VALUE ENGINEERING CONSTRUCTABILITY STUDY
OF THE

SR 92/FAIRBURN ROAD INTERCHANGE WITH I-20

PROJECT NUMBER: IM-NH-20-1(73)

August 14-15, 2006

VII. DEVELOPMENT SECTION
I. STAGE CONSTRUCTION
A. TEMPORARY DETOUR
1. "AS PROPOSED"

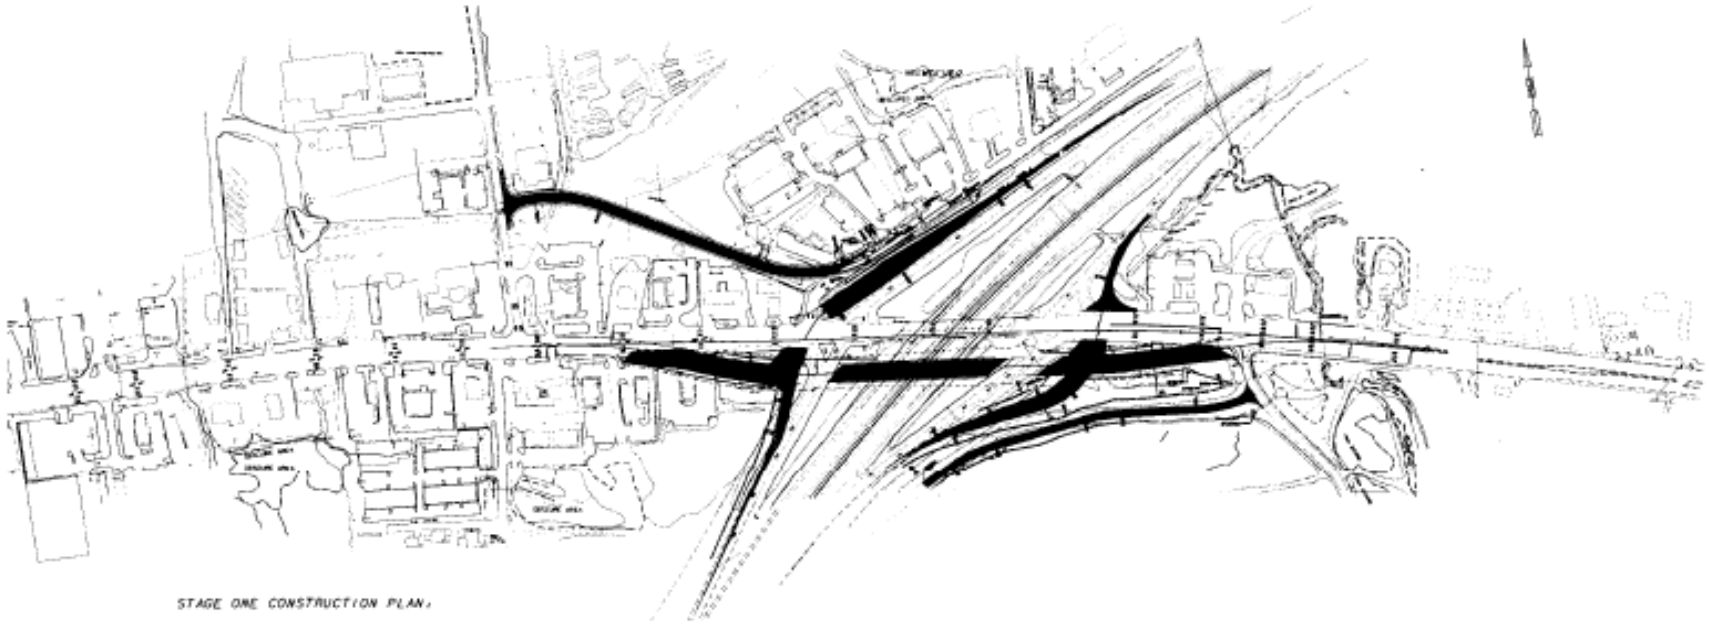
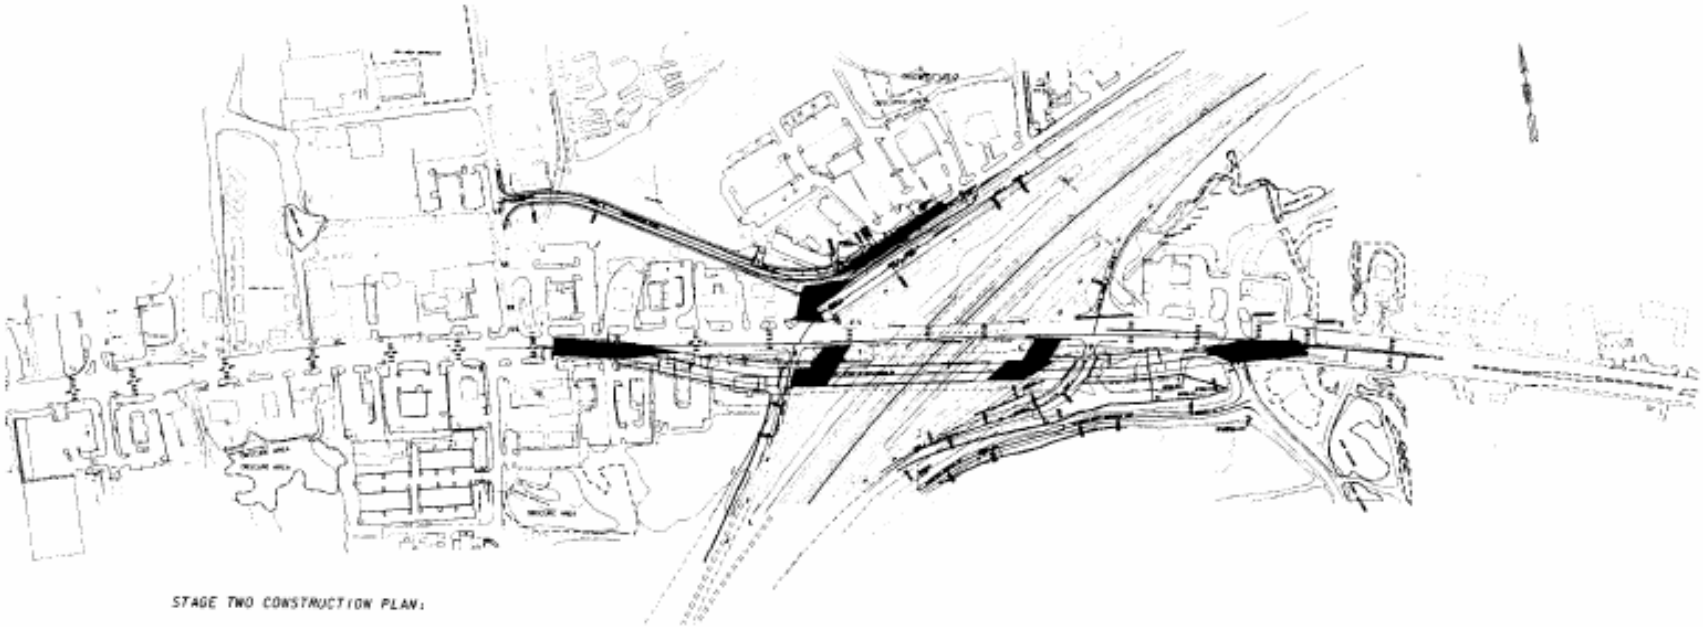
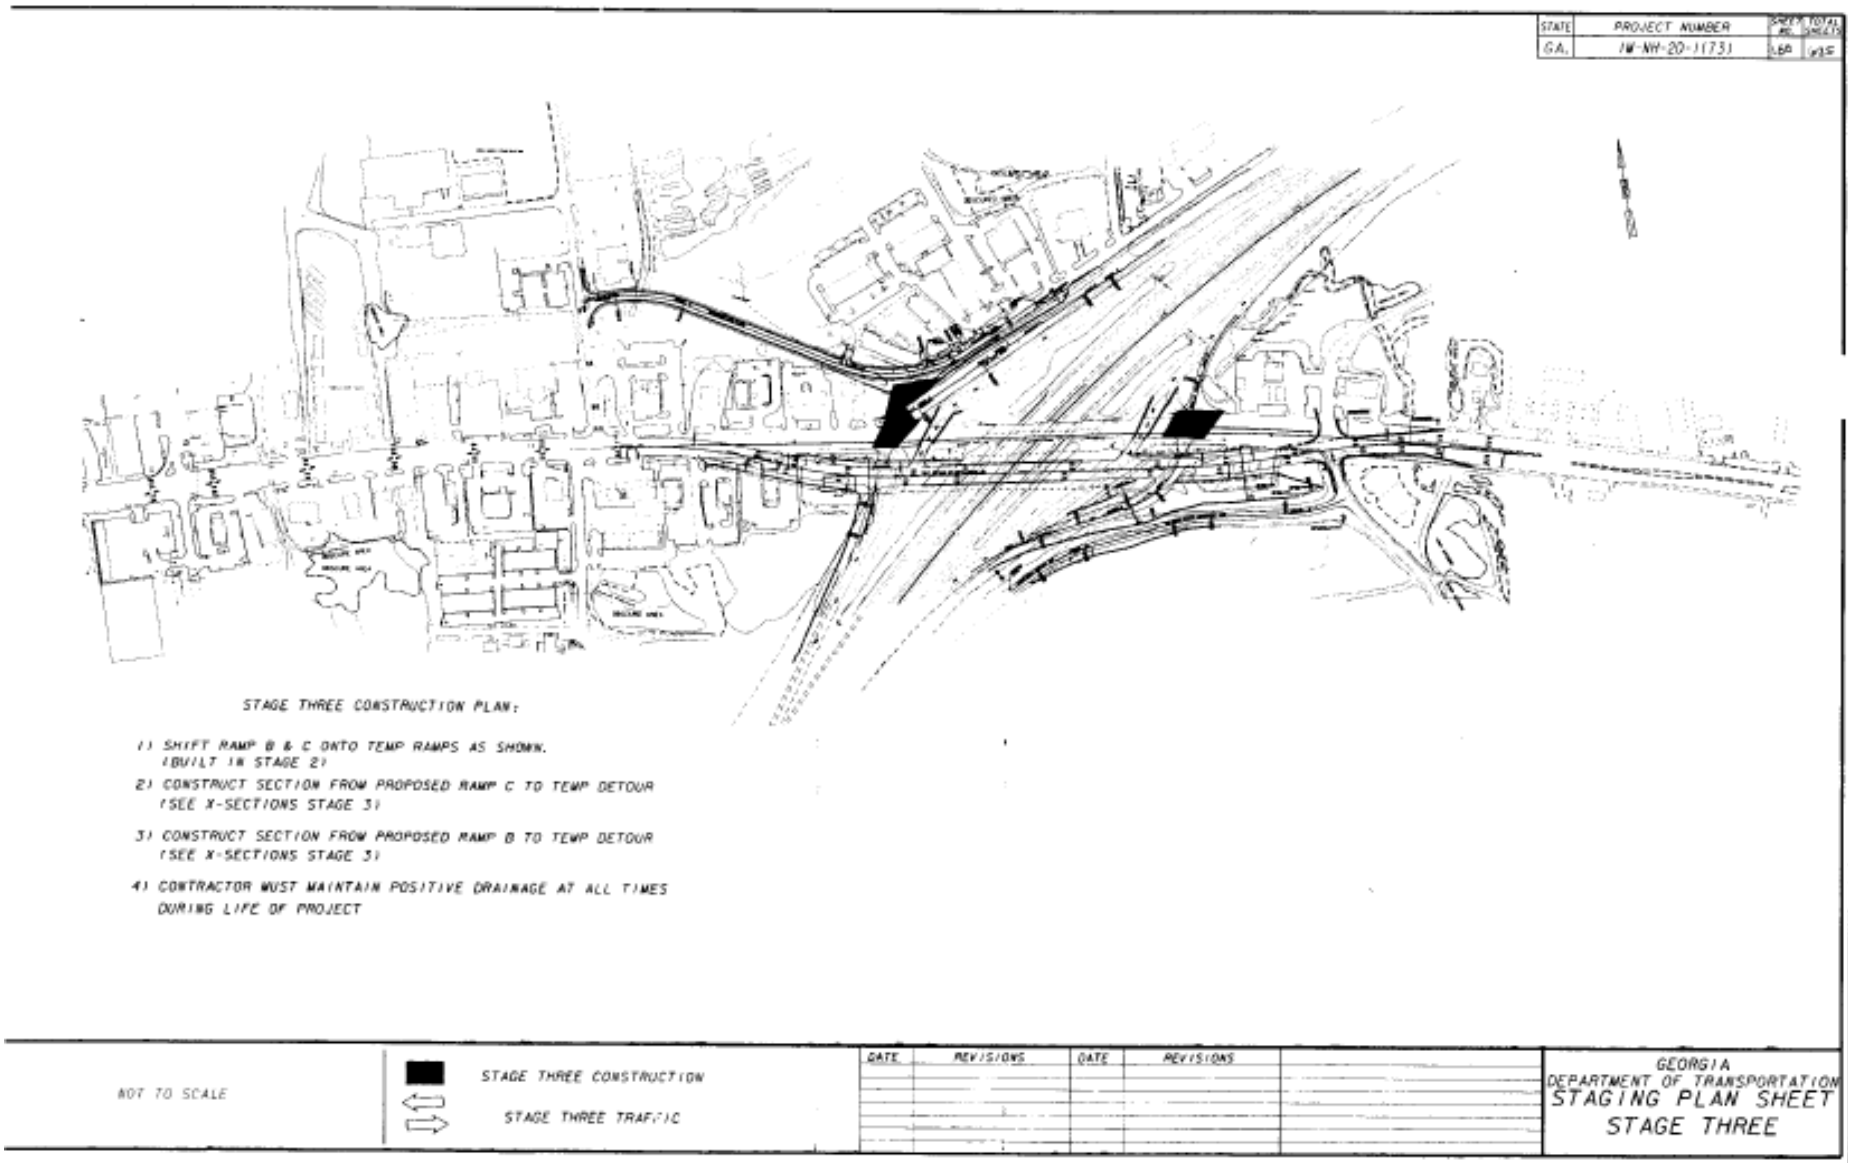
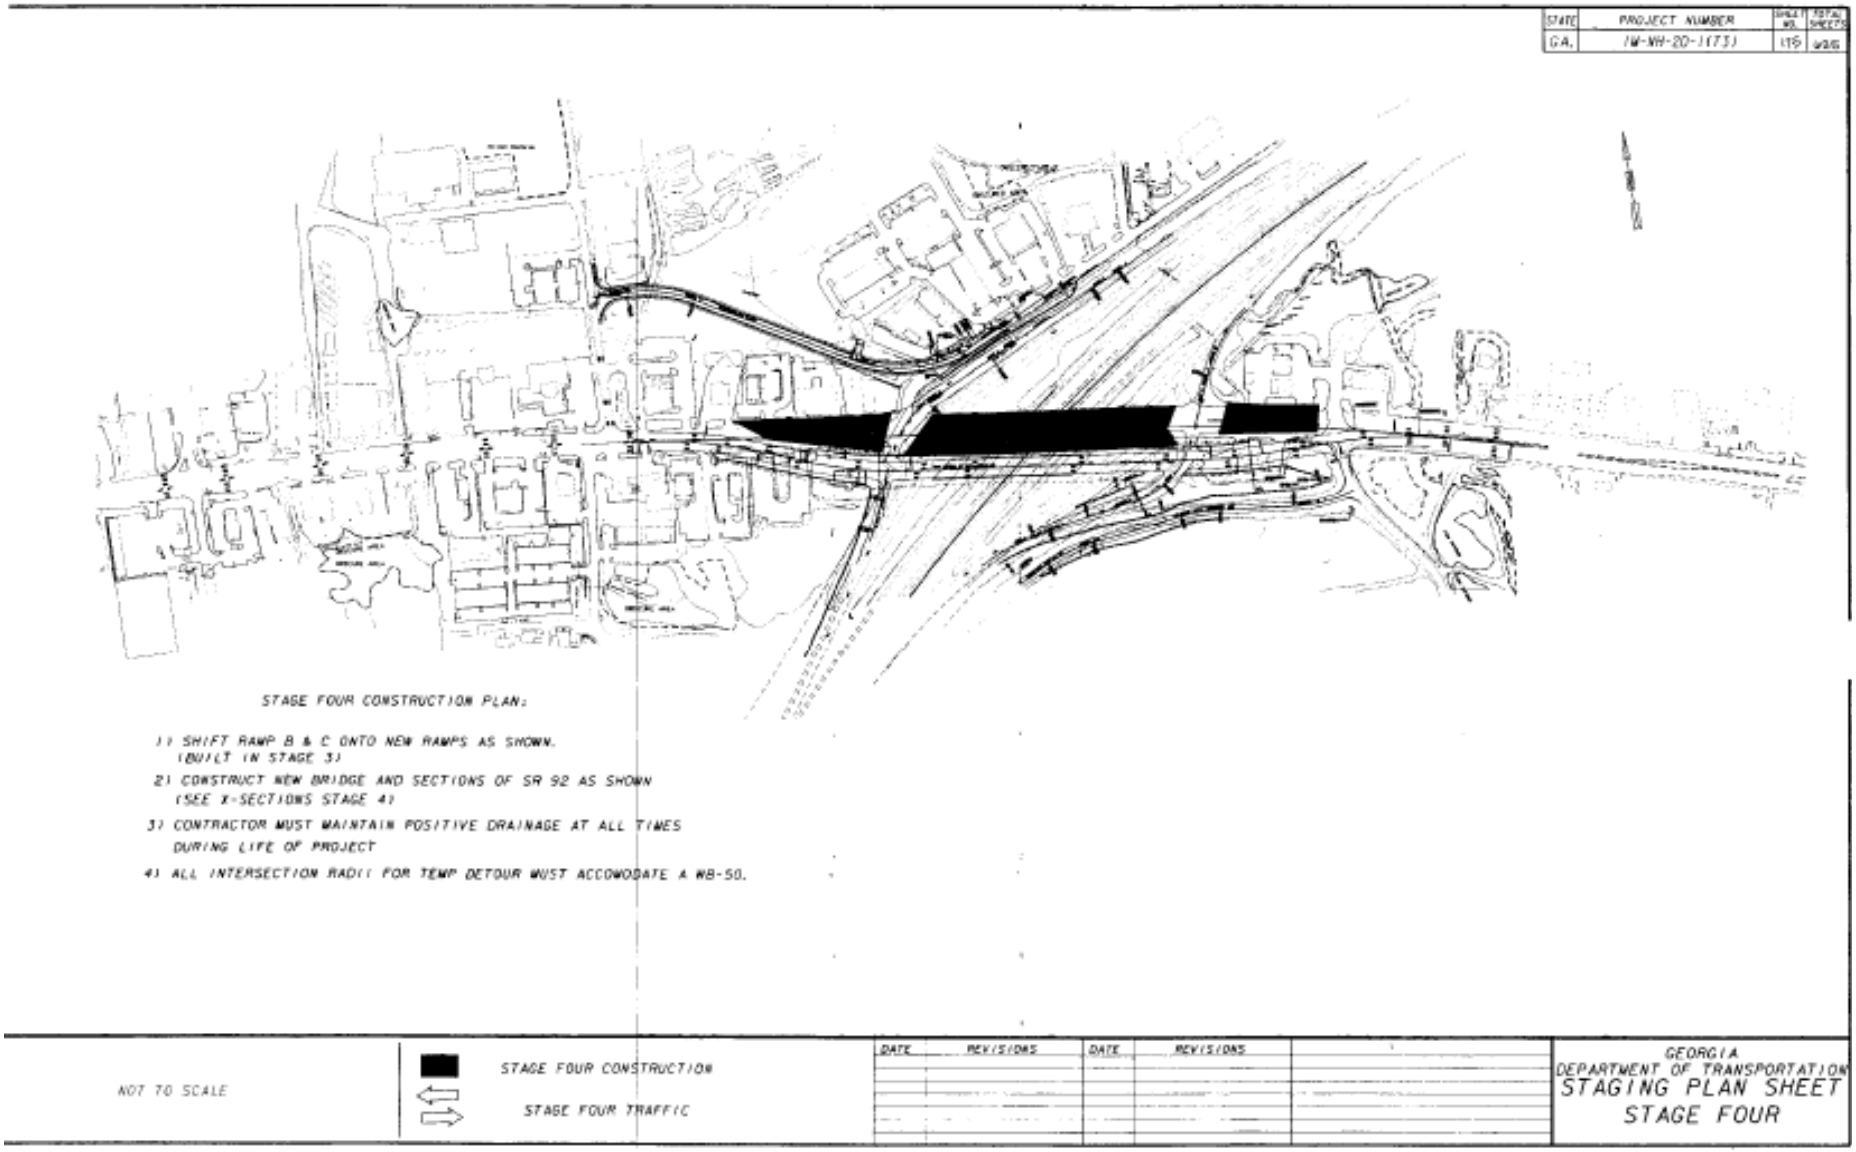
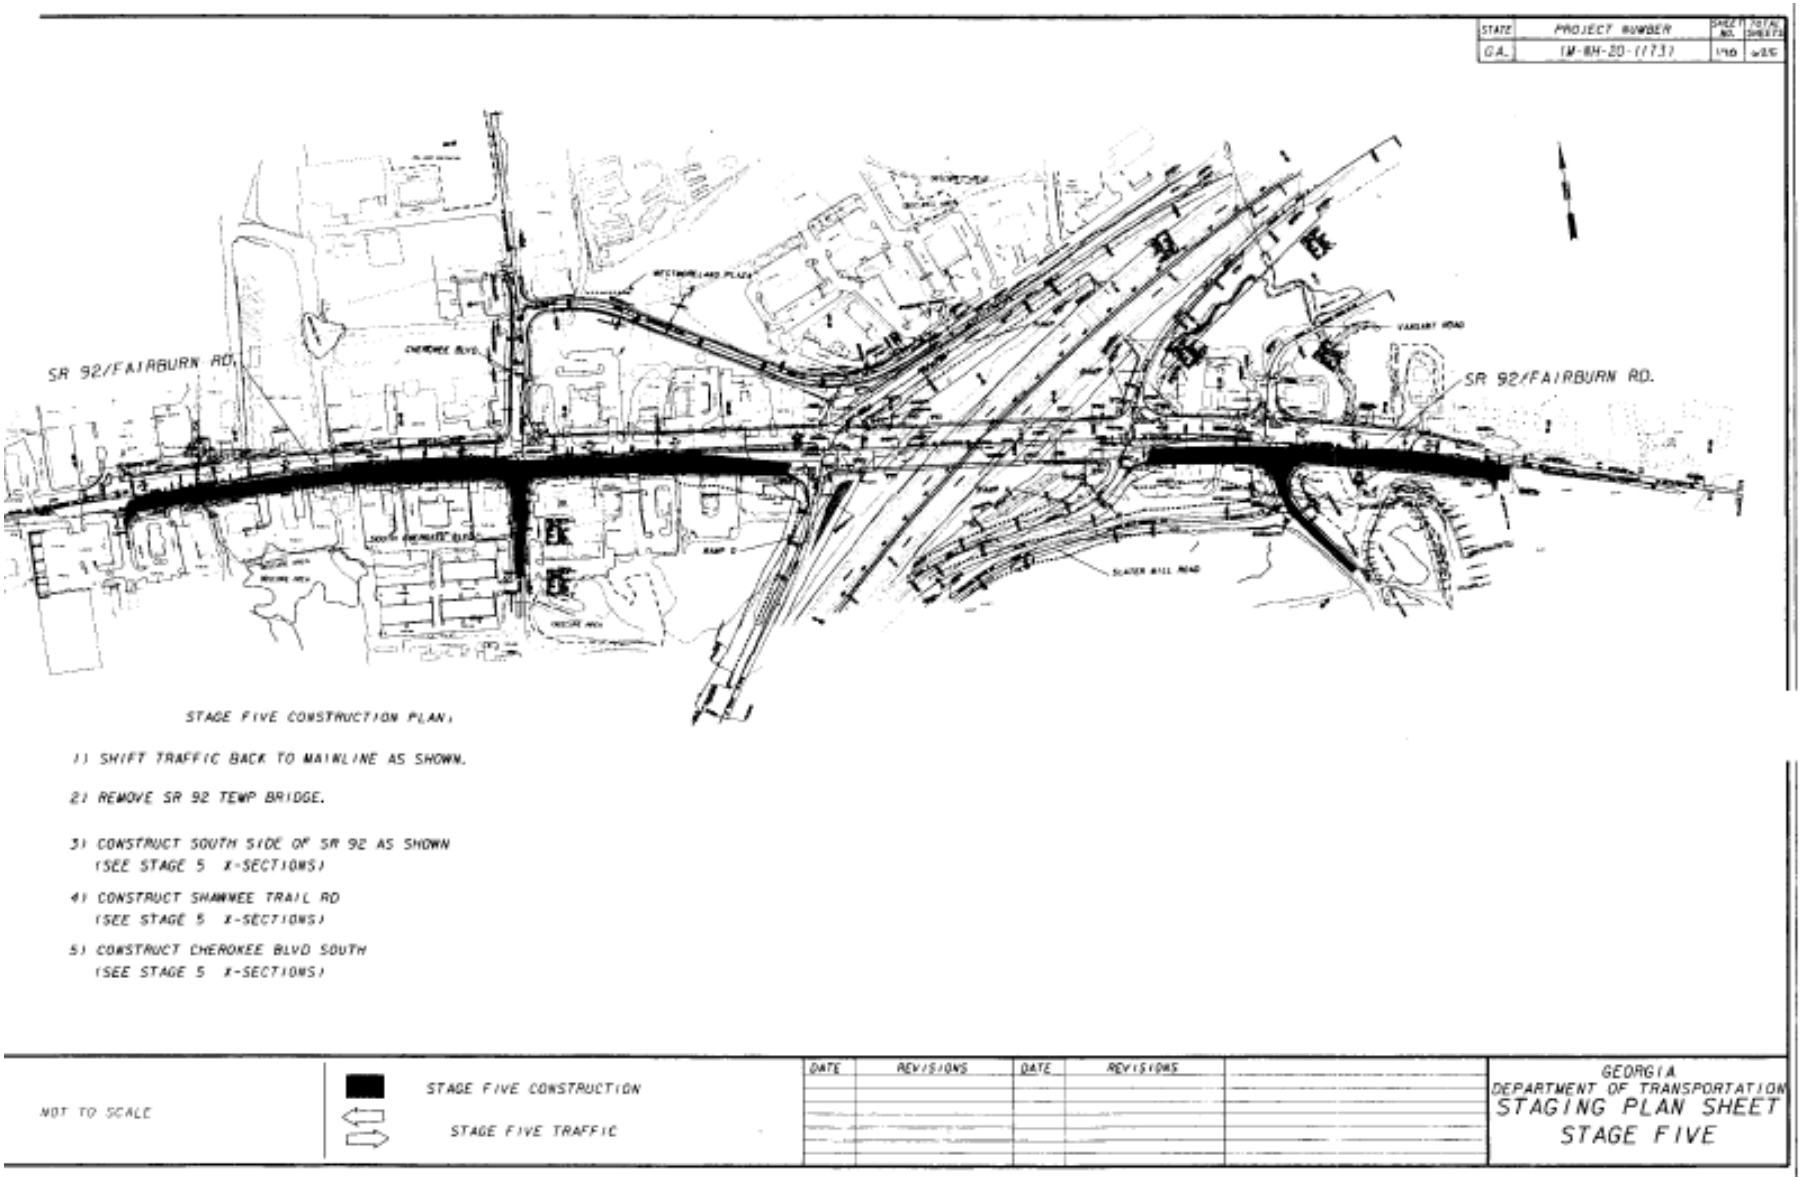
I. Stage Construction/Constructability: Six Stages with Temporary Detour Bridge.

The profile grade along SR 92 will be raised approximately 8 ft. at each end of the proposed new bridge. This difference in elevation is the major reason for the proposed construction plans containing six individual steps in the construction staging sequence. The staging requires the construction of a temporary detour bridge along the right side of the existing SR 92 Bridge over I-20. The proposed temporary bridge is estimated to cost between $700,000 and $900,000 to install and remove as part of the staging plan. The temporary bridge will shift the traffic farther to the right along existing SR 92 and will reduce the profile grade of the detour only slightly less than 1 ft. compared to the as-planned final elevation of the permanent SR 92 Bridge. The only flexibility that is gained is from the temporary bridge being moved farther away from the existing bridge for side slope and lateral clearance, total demolition of the existing bridge and the ability to break the roadway into smaller segments.

The new bridge is 439 ft. long and 140 ft. wide, and the grade is raised approximately 8 ft. The span lengths are 2 end spans at 49 ft. and a 2 span continuous plate girder at 170 ft. each. The end bents are pile supported while the 3 interior bents are on deep spread footings. The end abutments are of the spill through type with 2 to 1 end slopes. The detour bridge is shown as a 63 ft. wide, 4 span 346 ft. long structure. The Contractor will design, construct and remove the detour bridge.

The Value Engineering Alternative will construct the project in two stages. This will require shifting the centerline to the right so the left side of the proposed bridge and the left side of existing bridge match. The change will also eliminate the need for the detour bridge.
